Application is hereby made for revising the plan(s) for: Preliminary/Final Land Development Plans for JPMorgan Chase Bank

RE: Preliminary/Final Land Development Plan Review
JPMorgan Chase Bank, N.A.
1729 Street Road
TMP # 02-043-305
Bensalem Township, Bucks County, PA
Project No. BENS R 1280

We are in receipt of the JPMorgan Chase Bank, N.A. Preliminary/Final Land Development Plan Review Letter dated July 14, 2021. Please find enclosed responses to the previously mentioned documents.

SHEET NO.
C5.2
SHEET 6 OF 23

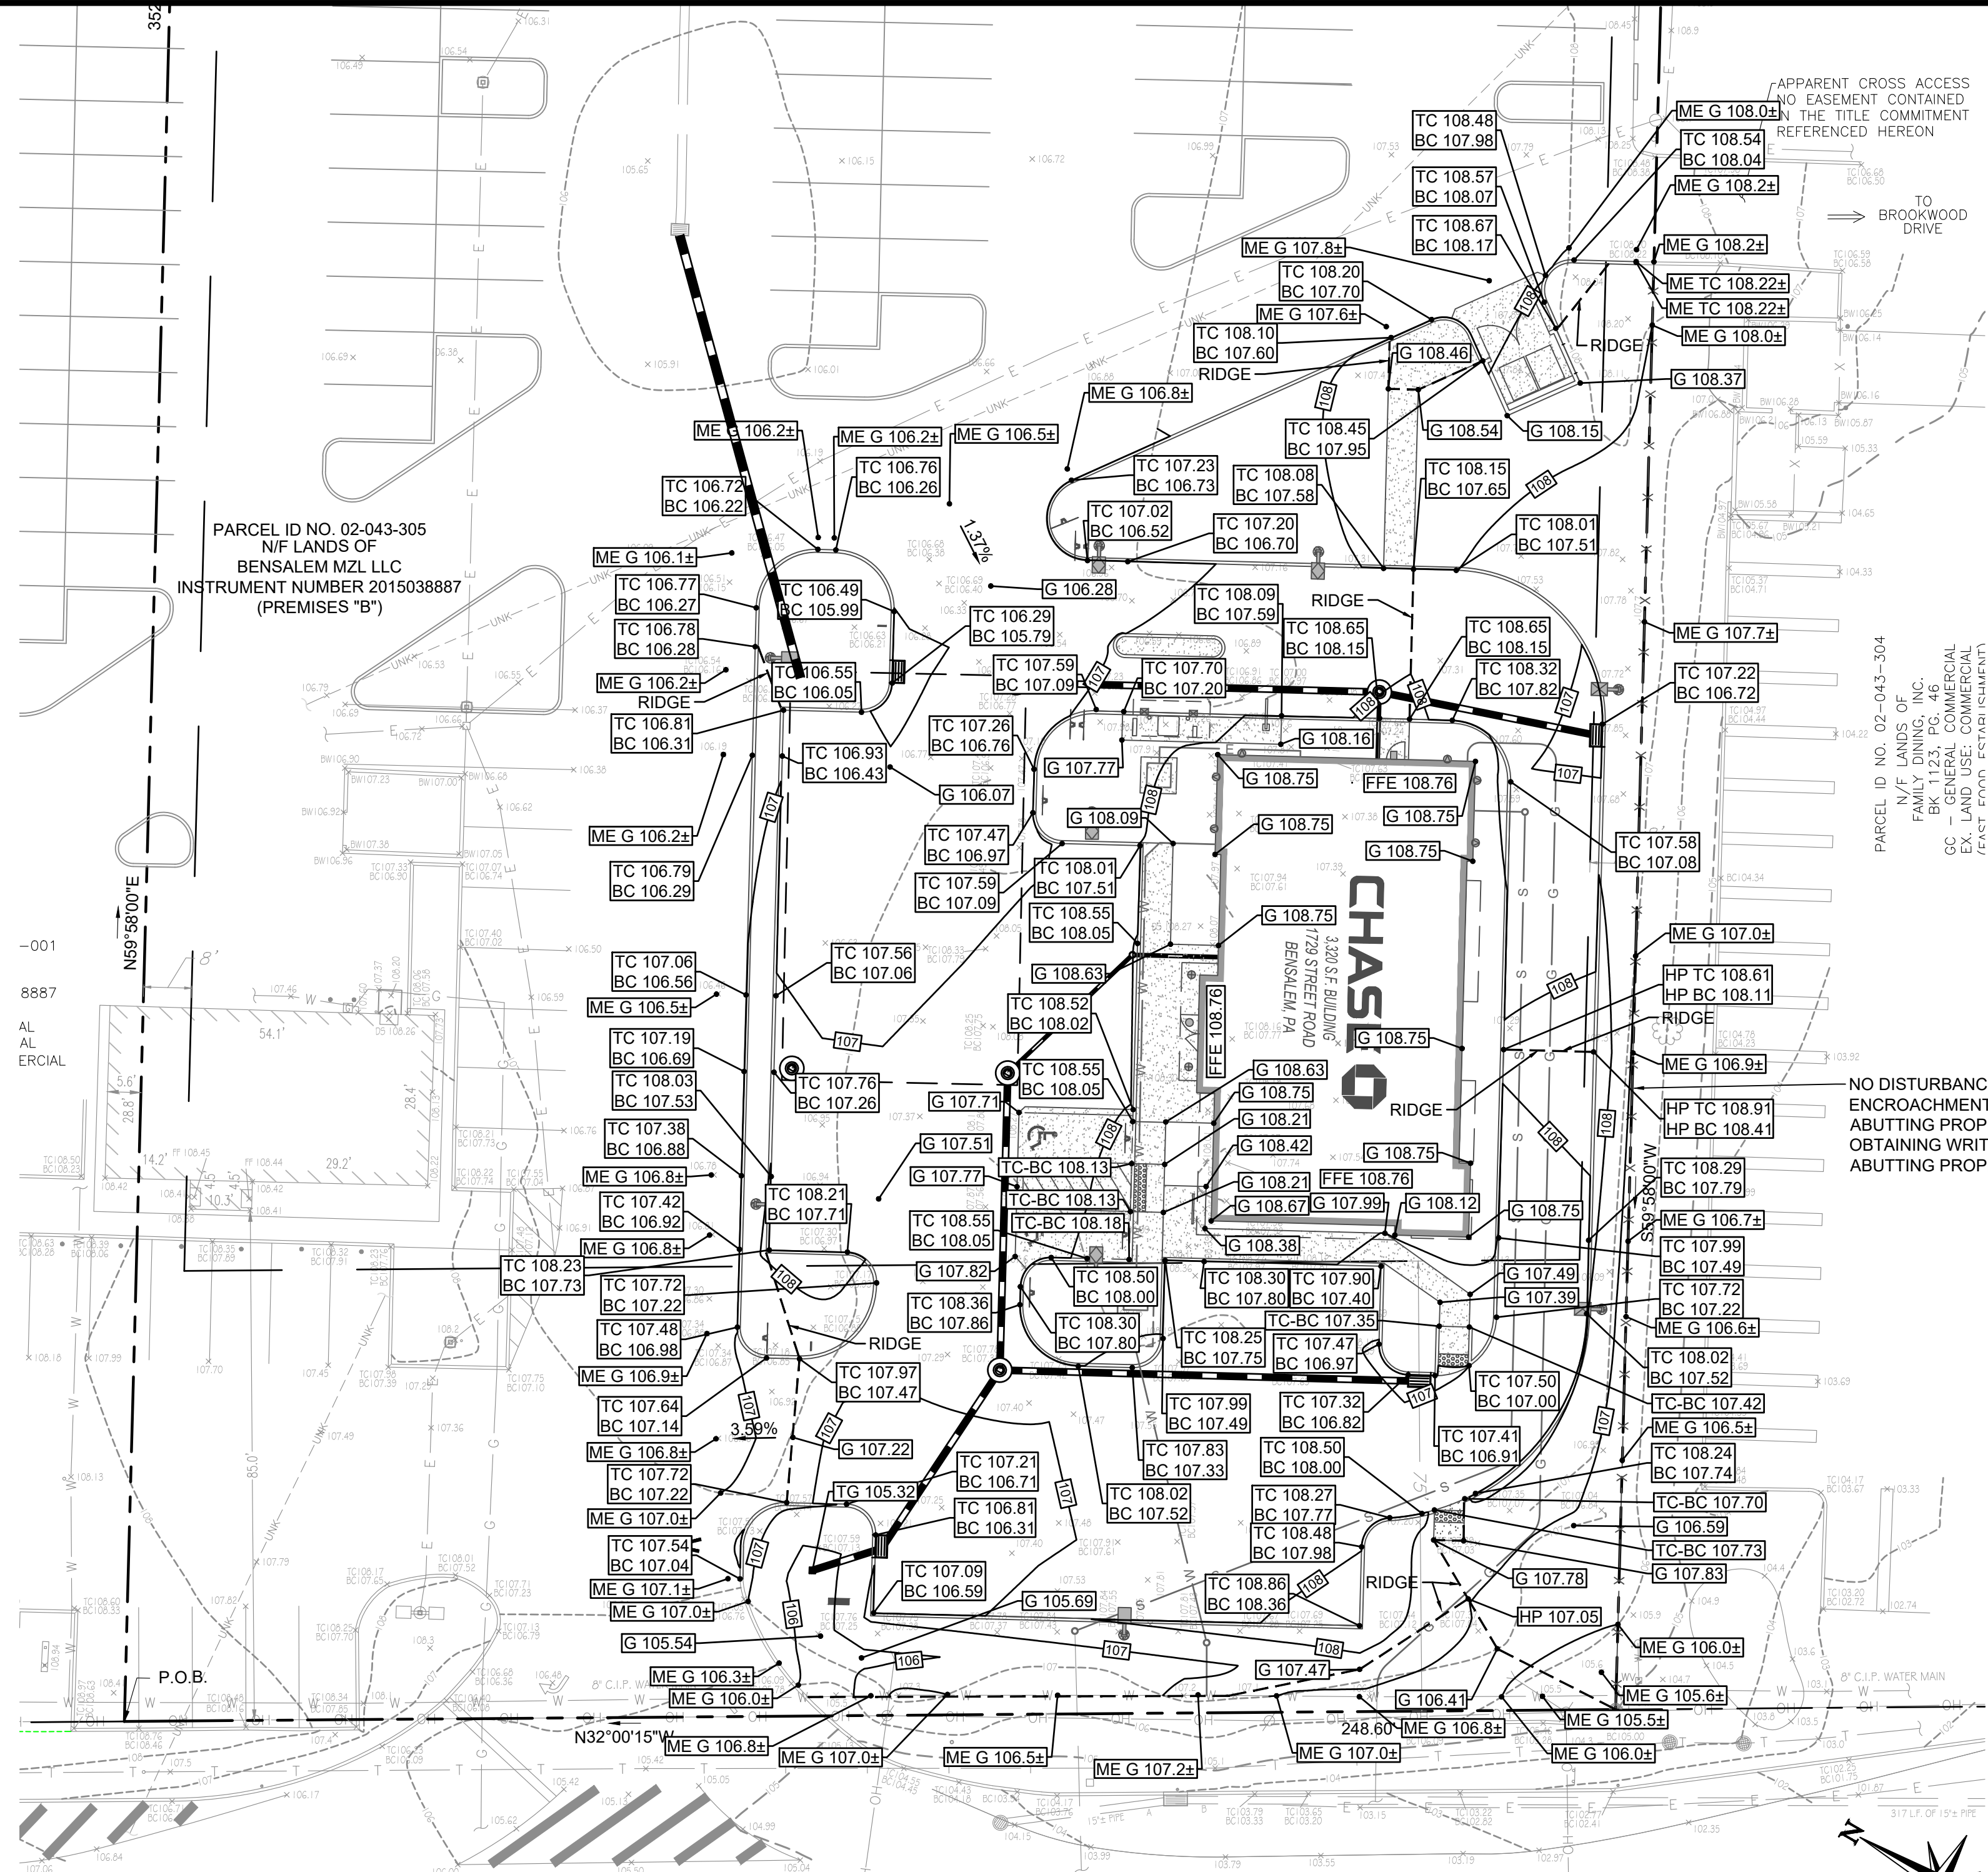
As mentioned above, provide a plan showing the entire parcel and all existing buildings, structures and streets and provide the following information on the record plan:

- a. Show and dimension the half and full cartway of Street Road.
- b. Show and dimension the existing right-of-way width of Street Road (full and half width).

Revise the plan set to include a full (plan sheet) size high-quality color aerial which shows existing features for 400 feet beyond the property boundary and delineates the site boundary.

The Alta/NSPS plan references various deed restrictions, rights-of-way and agreements. This information should be on added to a plan sheet that is going to be recorded.

Response 3 **Completed. An aerial has been provided to show existing buildings and other structures within the proposed development Please see the Overall Site Plan – Sheet C5.2 (Sheet 6 of 23).**

- Response 4** **Completed. An aerial has been provided to show existing buildings and other structures within 400 feet of the proposed development Please see the Overall Site Plan – Sheet C5.2 (Sheet 6 of 23). The various deed restrictions, rights-of-way and agreements have also been added to the plan.**
